Port Hills zoning review

Port Hills Zoning Review: Zoning Changes

Map 13: Mt Pleasant

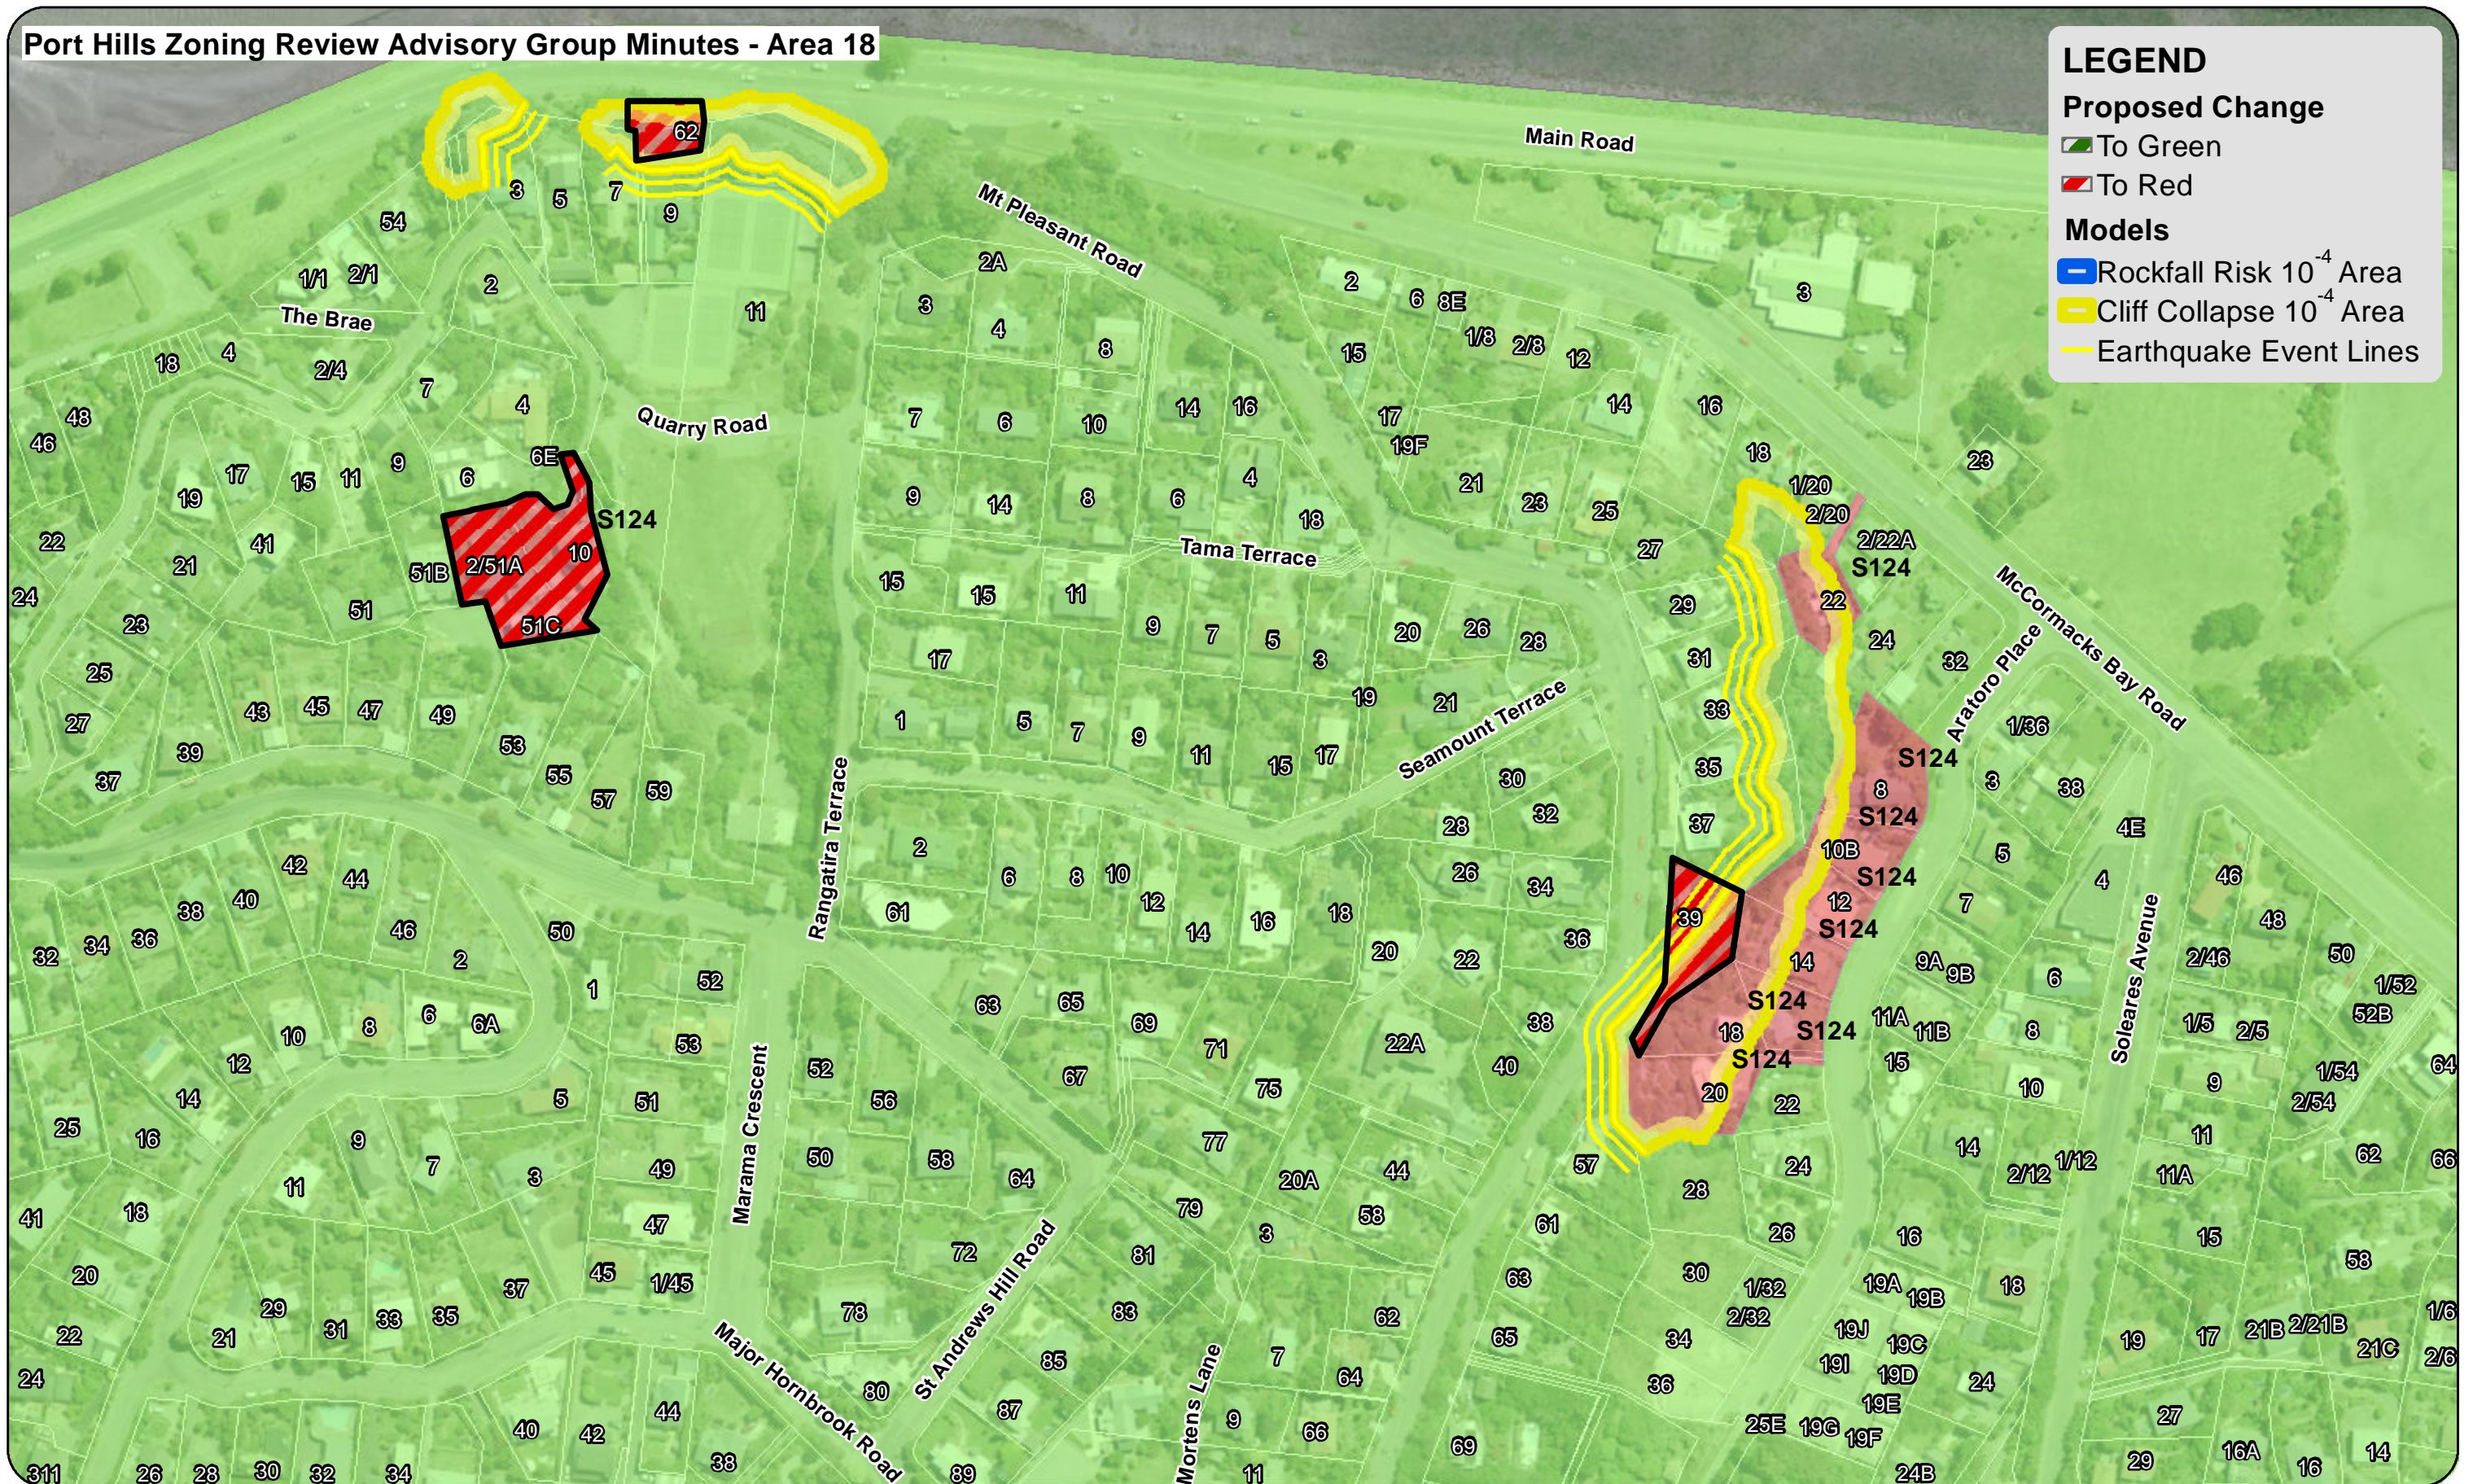
- 10 Quarry Road, and 2/51A and 51C St Andrews Hill Road:

Expert advice provided to the Group indicated that these properties are exposed to the potential for immediate land damage with an associated risk to life as a result of the earthquakes. The properties are affected by cliff recession and debris inundation. The cliff was not included in the GNS cliff collapse model but is exhibiting significant instability.

- Properties bordering Main Road (e.g. 3 and 7 Quarry Road):

Based on expert advice the GNS cliff collapse model tends to overstate the risk to these properties and there is no evidence that there is an immediate risk to life.

- Properties on McCormacks Bay Road, below Mt Pleasant Road (e.g. 18, 1/20 and 2/20 McCormacks Bay Road) and 57 Mt Pleasant Road:

The GNS cliff collapse risk model tends to overstate the risk to these properties as they are located at the end of the cliff (where it turns into a steep slope) and this creates a model boundary effect in the GNS model. (The GNS model, like all numerical models, becomes less certain at the edges of the modelled area due to inherent model assumptions and mathematical constraints.)

- Property at 28 Aratoro Place:

The GNS cliff collapse risk model tends to overstate the risk to this property as it is located on a steep slope, rather than a cliff, and this creates a model boundary effect in the GNS model. (The GNS model, like all numerical models, becomes less certain at the edges of the modelled area due to inherent model assumptions and mathematical constraints.)

Map 14: Maffeys Road

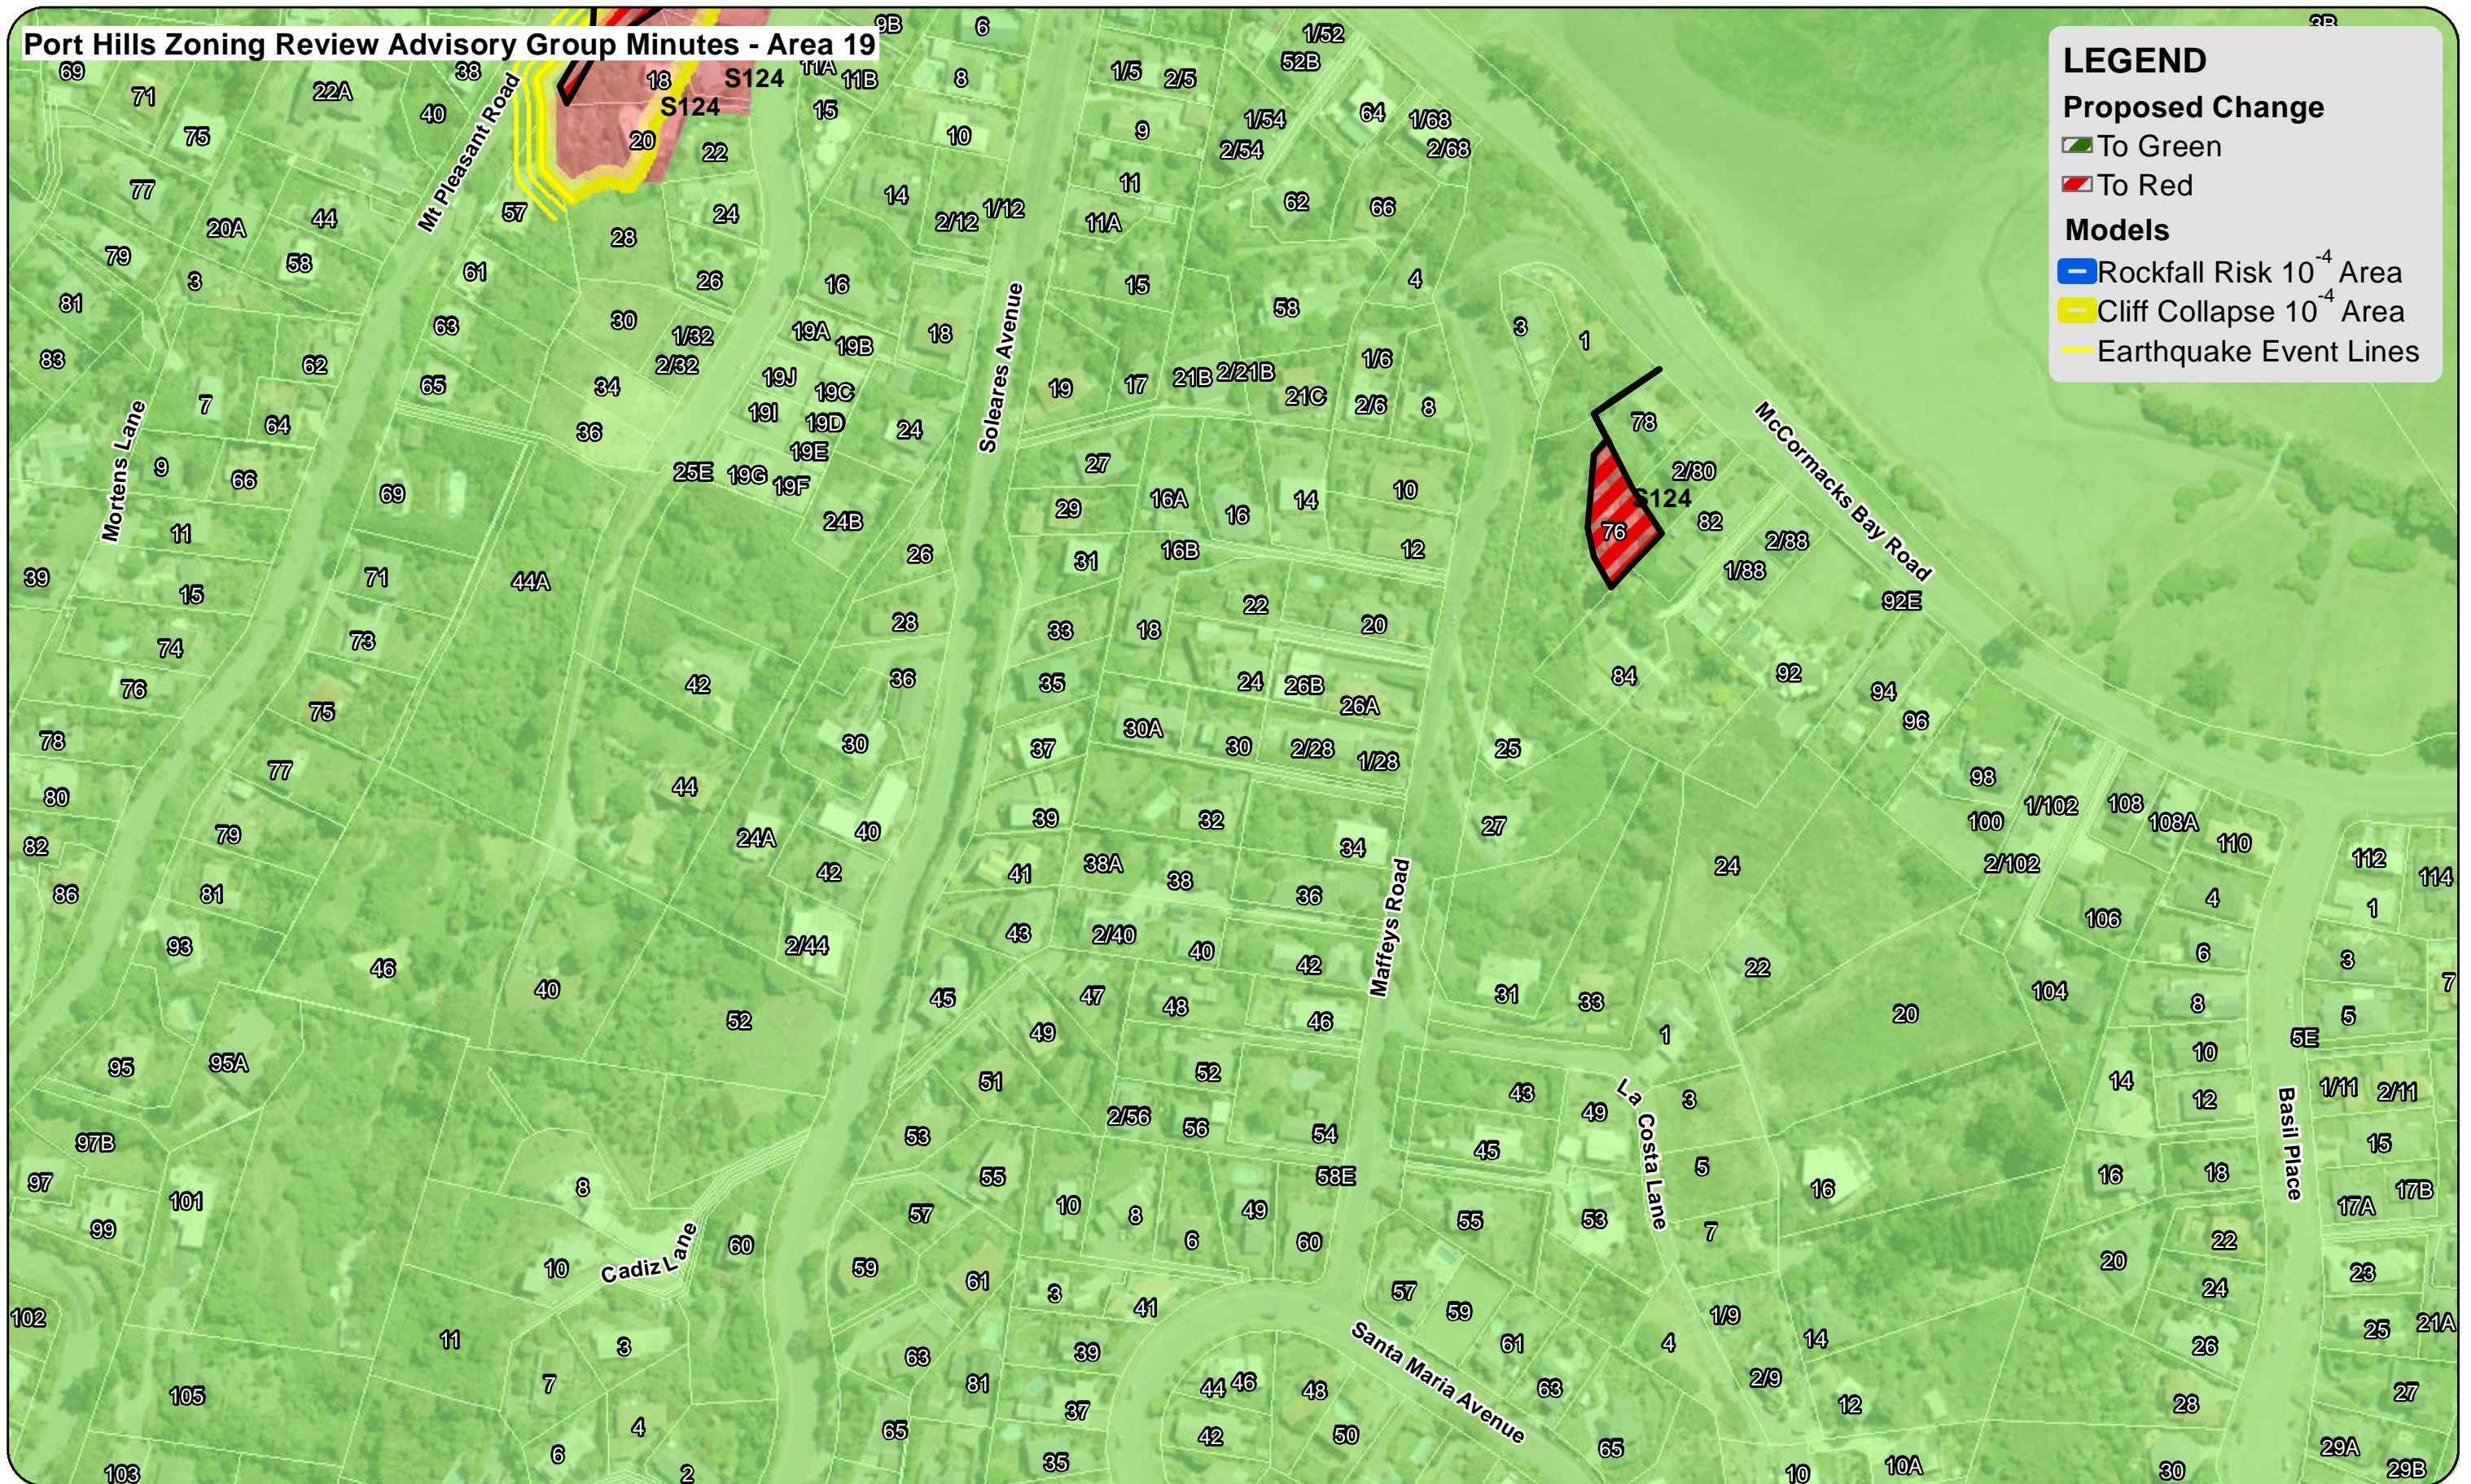
- 76 McCormacks Bay Road:

This property is exposed to the potential for immediate land damage with an associated risk to life. The sub-vertical loess (soil) slope bank immediately upslope of this property shows signs of ongoing distress (as evidenced by ground cracking), suggestive of ongoing ground movement. There is a high possibility of collapse which is considered to pose a direct life safety risk to occupants. Ground damage is earthquake exacerbated, though not necessarily earthquake caused, and mitigation options are unclear.
